AFFIDAVIT OF CORRECTION

To correct certain dimensions and bearings of North Lake Hills Addition, Final Plat, in the SW 1/4 of Section 23, Township 16 North, Range 12 East of the 6th P. M., Douglas County, Nebraska.

Correction to North Lake Hills Addition, Final Plat, a subdivision in the SW 1/4 of Section 23, Township 16 North, Range 12 East of the 6th P. M., Douglas County, Nebraska

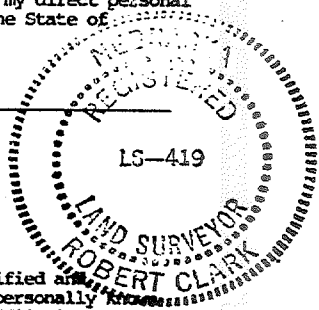
- The Westerly bearing of North Lake Hills Addition to read N00°17'36"W instead of N2°28'16.0"W.
- The Northwesterly bearing of North Lake Hills Addition to read N44°49'24"E instead of N42°49'20.6"E.

- The Northwesterly dimension of North Lake Hills Addition to read 928.42 feet instead of 929.33 feet.
- The Northerly bearing of North Lake Hills Addition to read N89°51'29"E instead of N87°39'23.0"E.

- The Zasterly bearing of North Lake Hills Addition to read S00°13'25"E instead of S2°22'08.2"E.
- The Southerly bearing of North Lake Hills Addition to read S64°52'44"W instead of S62°41'46"W.

- The Southerly dimension of North Lake Hills Addition to read 275.65 feet instead of 275.71 feet.
- The Southerly bearing of North Lake Hills Addition to read S70°35'23"W instead of S68°24'24"W.

- The Southerly dimension of North Lake Hills Addition to read 100.48 feet instead of 100.50 feet.
- The Southerly bearing of North Lake Hills Addition to read S64°52'40"W instead of S62°41'46"W.

- The Southerly dimension of North Lake Hills Addition to read 399.91 feet instead of 400.00 feet.
- The Southerly bearing of North Lake Hills Addition to read S59°09'59"W instead of S56°59'08"W.

- The Southerly dimension of North Lake Hills Addition to read 100.48 feet instead of 100.50 feet.
- The Southerly bearing of North Lake Hills Addition to read S64°52'39"W instead of S62°41'46"W.

- The Southerly dimension of North Lake Hills Addition to read 374.92 feet instead of 375.00 feet.
- The Southerly bearing of North Lake Hills Addition to read S70°42'24"W instead of S68°31'23"W.

- The Southerly dimension of North Lake Hills Addition to read 190.38 feet instead of 190.42 feet.

AFFIDAVIT OF CORRECTION

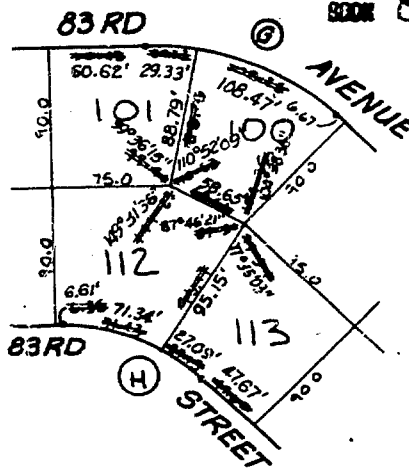
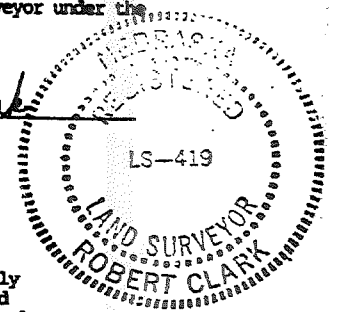
Curve Data (G)
 $\Delta = \cancel{154^\circ 57'}$ $45^\circ 07' 00''$
 $R = 200.00'$
 $T = \cancel{89.89'}$ $83.08'$
 $L = \cancel{167.78'}$ $157.49'$
 $D = 28.64789^\circ$

Curve Data (H)
 $\Delta = \cancel{154^\circ 57'}$ $45^\circ 07' 00''$
 $R = 100.00'$
 $T = \cancel{44.94'}$ $41.54'$
 $L = \cancel{89.89'}$ $78.74'$
 $D = 57.29578^\circ$

- The Westerly dimension of Lot 100 to read 108.47 feet instead of 108.25 feet.
- The Southerly dimension of Lot 100 to read 88.79 feet instead of 88.76 feet.

- The Easterly dimension of Lot 100 to read 58.65 feet instead of 58.56 feet.
- The Northeasterly angle of Lot 100 to read $104^\circ 38' 36''$ instead of $104-35$.

- The Southeasterly angle of Lot 100 to read $110^\circ 52' 09''$ instead of $110-53$.
- The Westerly dimension of Lot 101 to read 60.62 feet instead of 60.43 feet.

- The Northerly dimension of Lot 101 to read 29.33 feet instead of 29.73 feet.
- The Northerly dimension of Lot 101 to read 88.79 feet instead of 88.76 feet.

- The Northeasterly angle of Lot 101 to read $99^\circ 36' 15''$ instead of $99-44$.
- The Westerly dimension of Lot 112 to read 58.65 feet instead of 58.56 feet.

- The Northeasterly dimension of Lot 112 to read 95.15 feet instead of 95.17 feet.
- The Easterly dimension of Lot 112 to read 71.34 feet instead of 71.43 feet.

- The Easterly dimension of Lot 112 to read 6.61 feet instead of 6.35 feet.
- The Westerly angle of Lot 112 to read $149^\circ 31' 36''$ instead of $149-23$.

- The Northerly angle of Lot 112 to read $87^\circ 46' 21''$ instead of $87-51$.
- The Southwesterly dimension of Lot 113 to read 95.15 feet instead of 95.17 feet.

- The Southeasterly dimension of Lot 113 to read 47.67 feet instead of 47.60 feet.
- The Southeasterly dimension of Lot 113 to read 27.09 feet instead of 27.13 feet.

- The Westerly angle of Lot 113 to read $77^\circ 35' 03''$ instead of $77-34$.

AFFIDAVIT OF CORRECTION

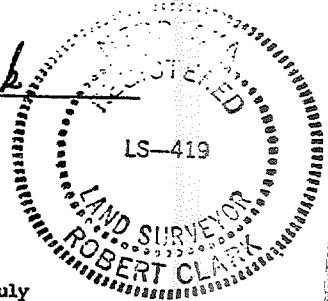
Curve Data (P) BOOK 805 PAGE 262
 $\Delta = \cancel{112.491504} 24^{\circ}49'44''$
 $R = 100.00'$
 $T = \cancel{22.02'} 22.01'$
 $L = \cancel{43.84'} 43.33'$
 $D = 57.29578^{\circ}$

The Southerly dimension of Lot 124 to read 79.69 feet instead of 79.55 feet.
 The Southerly dimension of Lot 124 to read 32.50 feet instead of 32.51 feet.
 The Southerly dimension of Lot 124 to read 28.93 feet instead of 29.04 feet.
 The Easterly dimension of Lot 124 to read 89.16 feet instead of 89.11 feet.
 The Northeasterly angle of Lot 124 to read 109°49'44" instead of 114-50.

AFFIDAVIT OF CORRECTION

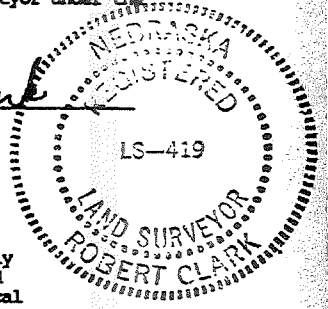
Curve Data (H)
 $\Delta = \del{45.10} 45^{\circ}07'00''$
 $R = 100.00'$
 $T = \del{41.60} 41.54'$
 $L = \del{70.85} 70.74'$
 $D = 57.29578^{\circ}$

The Northwesterly dimension of Lot 118 to read 62.67 feet instead of 62.58 feet.
 The Northwesterly dimension of Lot 118 to read 29.53 feet instead of 29.57 feet.
 The Southeasterly dimension of Lot 118 to read 52.28 feet instead of 52.17 feet.
 The Southerly angle of Lot 118 to read 112°33'30" instead of 112-35.
 The Westerly dimension of Lot 119 to read 29.53 feet instead of 29.57 feet.
 The Westerly dimension of Lot 119 to read 71.61 feet instead of 71.35 feet.
 The Easterly dimension of Lot 119 to read 61.23 feet instead of 60.94 feet.
 The Northeasterly angle of Lot 119 to read 112°33'30" instead of 112-35.

AFFIDAVIT OF CORRECTION

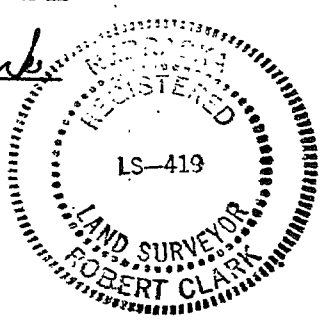
- The Westerly dimension of Lot 159 to read 21.86 feet instead of 22.20 feet.
- The Southerly dimension of Lot 159 to read 88.64 feet instead of 87.50 feet.

- The Easterly dimension of Lot 159 to read 90.00 feet instead of 81.50 feet and 8.63 feet.
- The Southeasterly angle of Lot 159 to read 90°00'00" instead of 79-13.

- The Easterly angle 150-47 of Lot 159 to be eliminated.
- The Westerly dimension of Lot 160 to read 80.30 feet instead of 79.33 feet.
- The Westerly dimension of Lot 160 to read 11.28 feet instead of 10.74 feet.

- The Northerly dimension of Lot 160 to read 88.64 feet instead of 87.50.
- The Easterly dimension of Lot 160 to read 91.88 feet instead of 91.62 feet.
- The Southerly dimension of Lot 160 to read 90.22 feet instead of 91.62 feet.

- The Southwesterly angle of Lot 160 to read 100°50'59" instead of 100-47.
- The Southeasterly angle of Lot 160 to read 78°24'23" instead of 79-13.
- The Northeasterly angle of Lot 160 to read 101°35'37" instead of 100-47.

- The Westerly dimension of Lot 161 to read 86.55 feet instead of 86.53 feet.
- The Northerly dimension of Lot 161 to read 90.22 feet instead of 91.62 feet.

- The Easterly dimension of Lot 161 to read 86.77 feet instead of 86.53 feet.
- The Southerly dimension of Lot 161 to read 91.37 feet instead of 91.62 feet.

- The Northeasterly angle of Lot 161 to read 79°09'01" instead of 79-13.
- The Southeasterly angle of Lot 161 to read 101°35'37" instead of 100-47.
- The Southeasterly angle of Lot 161 to read 78°24'23" instead of 79-13.

- The Southwesterly angle of Lot 161 to read 100°50'59" instead of 100-47.
- The Westerly dimension of Lot 162 to read 42.61 feet instead of 42.35 feet.

- The Westerly dimension of Lot 162 to read 7.66 feet instead of 10.16 feet.
- The Northerly dimension of Lot 162 to read 91.37 feet instead of 91.62 feet.

- The Easterly dimension of Lot 162 to read 20.38 feet instead of 22.98 feet.
- The Easterly dimension of Lot 162 to read 67.60 feet instead of 67.43 feet.

- The Northeasterly angle of Lot 162 to read 79°09'01" instead of 79-13.
- The Southeasterly angle of Lot 162 to read 101°35'37" instead of 100-47.
- The Northerly angle of Lot 163 to read 127°47'43" instead of 127-47.5.

- The Easterly angle of Lot 163 to read 111°30'36" instead of 112-05.
- The Southeasterly angle of Lot 163 to read 120°41'39" instead of 120-07.5.
- The Southerly dimension of Lot 164 to read 81.98 feet instead of 79.56 feet.

- The Southerly dimension of Lot 164 to read 8.03 feet instead of 10.37 feet.
- The Easterly dimension of Lot 164 to read 99.57 feet instead of 98.57 feet.

AFFIDAVIT OF CORRECTION

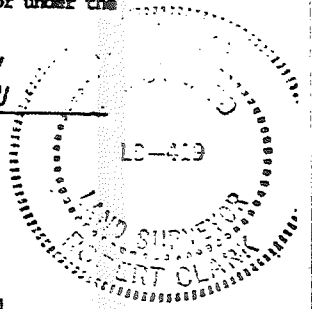
Curve Data (A)		Curve Data (B)	
$\Delta = \cancel{24^\circ 49' 58\"}$	$24^\circ 49' 45\"$	$\Delta = \cancel{24^\circ 49' 58\"}$	$24^\circ 49' 44\"$
R = 200.00'		R = 100.00'	
T = 44.03'		T = 82.02'	22.01'
L = 86.67'	86.67'	L = 163.31'	43.33'
D = 28.64789'		D = 57.29578'

- The Southwesterly angle of Lot 1 to read 71°00'00" instead of 70-59.5.
- The Southerly dimension of Lot 1 to read 159.13 feet instead of 159.17 feet.
- The Northerly dimension of Lot 1 to read 130.54 feet instead of 130.69 feet.

- The Easterly dimension of Lot 1 to read 81.06 feet instead of 77.40 feet.
- The South dimension of Lot 2 to read 130.54 feet instead of 130.69 feet.
- The Easterly dimension of Lot 2 to read 15.64 feet instead of 17.68 feet.

- The Easterly dimension of Lot 2 to read 54.57 feet instead of 52.38 feet.
- The Northerly dimension of Lot 4 to read 82.44 feet instead of 82.33 feet.

- The Northerly angle of Lot 4 to read 193°58'57" instead of 196-28.5.
- The Northeasterly angle of Lot 4 to read 76°01'03" instead of 73-31.5.
- The Southerly dimension of Drainage Way Lot to read 82.44 feet instead of 82.33 feet.

- The Southerly angle of Drainage Way Lot to read 166°01'03" instead of 163-31.5.
- The Southeasterly angle of Drainage Way Lot to read 103°58'57" instead of 106-29.5.

- The Westerly dimension of Lot 222 to read 2.37 feet instead of 0.62 feet.
- The Westerly dimension of Lot 222 to read 75.84 feet instead of 75.85 feet.

- The Westerly dimension of Lot 222 to read 44.85 feet instead of 45.90 feet.
- The Northerly dimension of Lot 222 to read 54.17 feet instead of 52.85 feet.

- The Northerly dimension of Lot 222 to read 15.59 feet instead of 15.76 feet.
- The Southeasterly angle of Lot 222 to read 90°00'01" instead of 90°00'00".

AFFIDAVIT OF CORRECTION

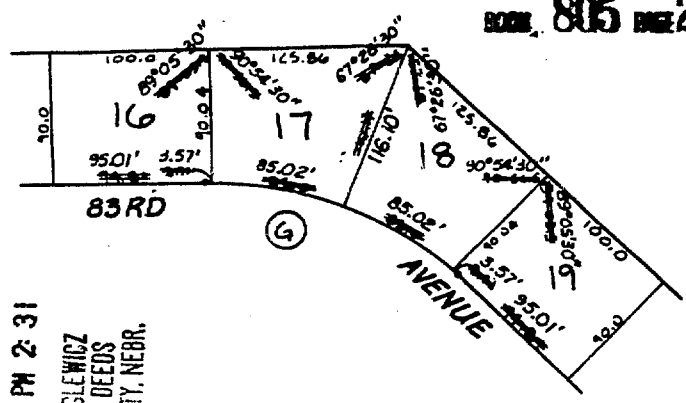
Curve Data D
Δ = ~~10°47'04\"~~ 10°50'59"
R = 200.00'
T = ~~18.88'~~ 18.99'
L = ~~37.64'~~ 37.87'
D = 28.64789°

Curve Data E
Δ = ~~10°47'04\"~~ 10°50'59"
R = 200.00'
T = ~~18.88'~~ 18.99'
L = ~~37.64'~~ 37.87'
D = 28.64789°

- The Westerly dimension of Lot 223 to read 224.97 feet instead of 226.00 feet.
- The Northerly dimension of Lot 223 to read 129.31 feet instead of 129.22 feet.

- The Easterly dimension of Lot 223 to read 15.51 feet instead of 16.47 feet.
- The Westerly dimension of Lot 7 to read 90.00 feet instead of 90.03 feet.

- The Northerly dimension of Lot 7 to read 112.97 feet instead of 112.84 feet.
- The Easterly dimension of Lot 7 to read 73.87 feet instead of 75.13 feet.

- The Easterly dimension of Lot 7 to read 17.63 feet instead of 16.47 feet.
- The Southerly dimension of Lot 7 to read 129.31 feet instead of 129.22 feet.

- The Northeasterly angle of Lot 7 to read 100°50'59" instead of 100-47.
- The Northerly dimension of Lot 8 to read 95.72 feet instead of 95.70 feet.
- The Easterly dimension of Lot 8 to read 91.64 feet instead of 91.62 feet.

- The Southerly dimension of Lot 8 to read 112.97 feet instead of 112.84 feet.
- The Northeasterly angle of Lot 8 to read 100°50'59" instead of 100-47.
- The Southeasterly angle of Lot 8 to read 79°09'01" instead of 79-13.

- The Southerly dimension of Lot 9 to read 95.72 feet instead of 95.70 feet.
- The Easterly dimension of Lot 9 to read 9.00 feet instead of 9.25 feet.
- The Easterly dimension of Lot 9 to read 42.61 feet instead of 42.35 feet.

- The Southeasterly angle of Lot 9 to read 79°09'01" instead of 79-13.

AFFIDAVIT OF CORRECTION

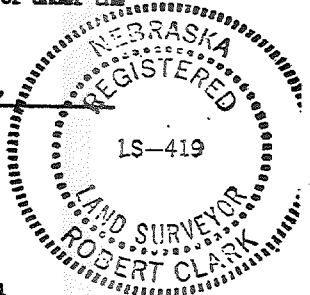
Curve Data G
 $\Delta = \cancel{45^{\circ}10'57''} 45^{\circ}07'00''$
 $R = 200.00'$
 $T = \cancel{83.20'} 83.08'$
 $L = \cancel{157.70'} 157.49'$
 $D = 28.64789^{\circ}$

- The Easterly dimension of Lot 16 to read 3.57 feet instead of 3.71 feet.
- The Easterly dimension of Lot 16 to read 95.01 feet instead of 94.81 feet.
- The Northwesternly angle of Lot 16 to read 89°05'30" instead of 89-03.5.

- The Northerly dimension of Lot 17 to read 116.10 feet instead of 116.17 feet.
- The Easterly dimension of Lot 17 to read 85.02 feet instead of 85.00 feet.

- The Southwesterly angle of Lot 17 to read 90°54'30" instead of 90-56.5.
- The Northwesternly angle of Lot 17 to read 67°26'30" instead of 67-25.
- The Southwesterly dimension of Lot 18 to read 116.10 feet instead of 116.17 feet.

- The Southeasterly dimension of Lot 18 to read 85.02 feet instead of 85.00 feet.
- The Westerly angle of Lot 18 to read 67°26'30" instead of 67-25.
- The Northerly angle of Lot 18 to read 90°54'30" instead of 90-56.5.

- The Southeasterly dimension of Lot 19 to read 95.01 feet instead of 94.81 feet.
- The Southeasterly dimension of Lot 19 to read 3.57 feet instead of 3.71 feet.

- The Westerly angle of Lot 19 to read 89°05'30" instead of 89-03.5.
